LONG ISLAND LIGHTING COMPANY

SNRC-1158

Submittal of FHAR Revision
Shoreham Nuclear Power Station - Unit 1
Docket No. 50-322

FOR REVISION 2 TO THE FHAR

FIGURE 1B

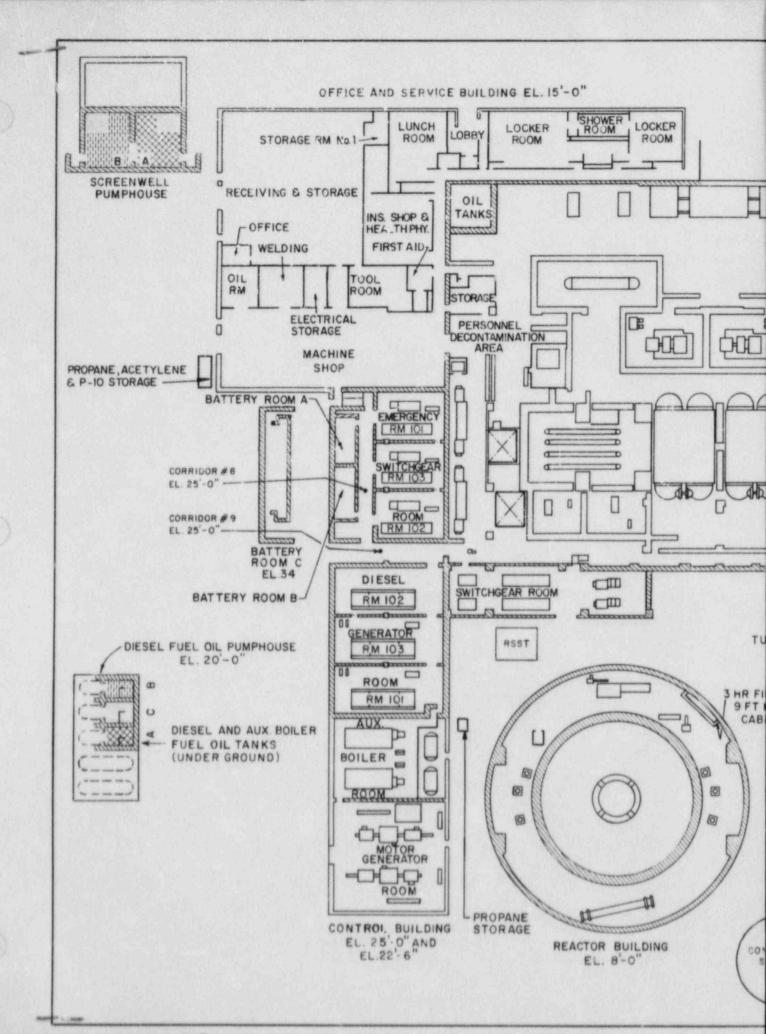
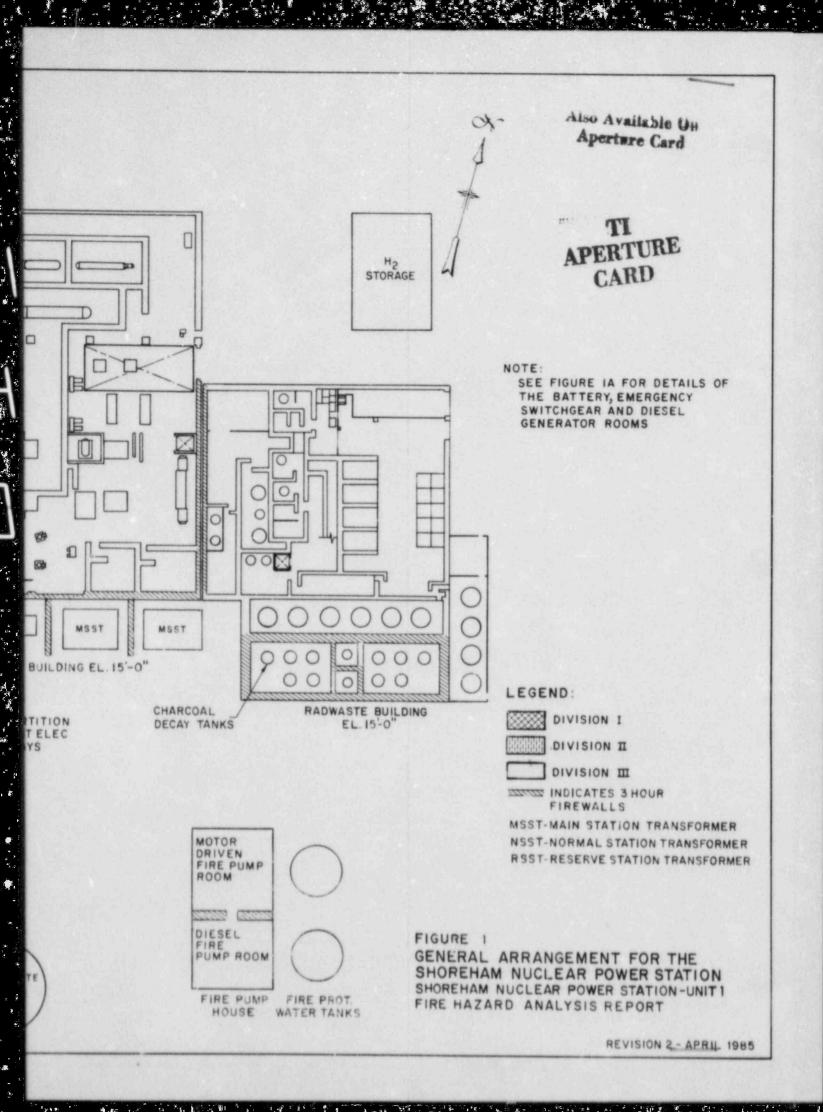
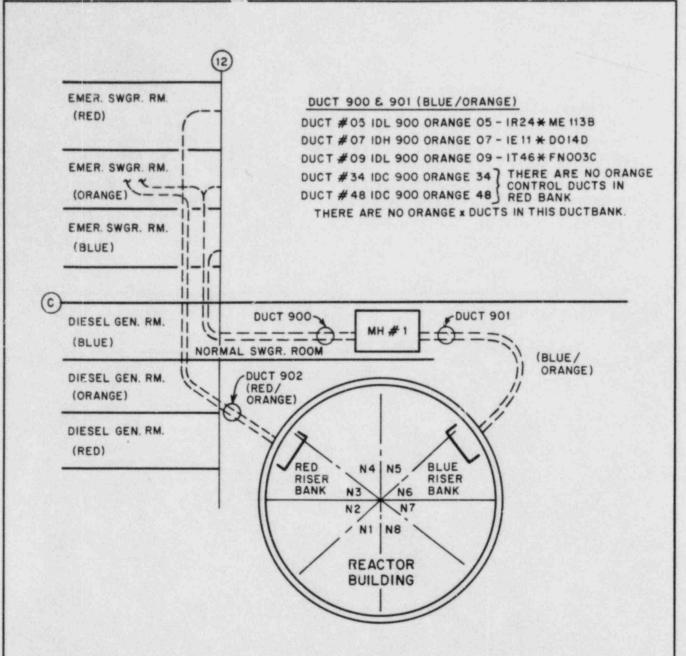
PLANT FIRE AREA DESCRIPTION - ELECTRIC MANHOLE NO. 1 (Refer to Figure 1B)

Design Features	Construction	Rating	
Walls:	18 in. Reinforced Concrete	>4 hr	
Floor:	18 in. Reinforced Concrete	>4 hr	
Cover:	24 in. Reinforced Concrete	>4 hr	
Ducts:	Sealed at both ends

Loss of blue and orange cables in manhole. No spread of fire through duct lines to adjacent areas will occur since the ducts are sealed.

Due to redundant (red) cable in duct 902 outside the area and the protective devices (breakers and/or fuses) at the orange cables in duct 900 (thus orange cables in duct 902 not affected), a

plant safe shutdown will not be impaired by the loss of blue and orange cables in the manhole (see Figure 1B).

FIGURE 2A

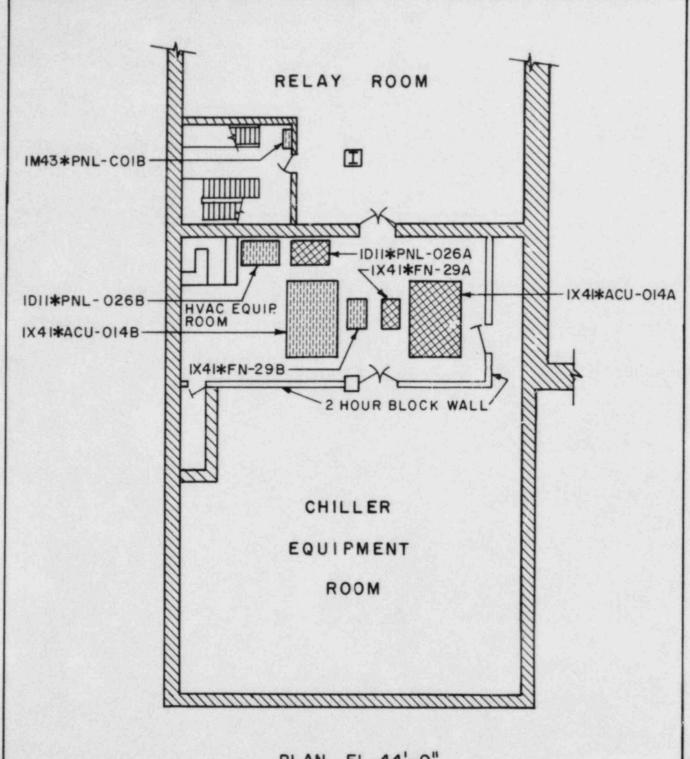
- Item 84-46-10 Design concentration of CO₂ in Battery Rooms and cable tunnel,
- 2) Item 84-46-13 Lack of Fire Hazards Analysis for Electric Manhole #1 and Control Building corridors No. 8 and No. 9,
- 3) Item 84-46-09 Lack of fire damper in duct between HVAC Equipment Room and Chiller Room.

This information should be suitable to close inspection item 84-46-10. Plant modifications associated with items 84-46-13 and 84-46-09 are presently in progress.
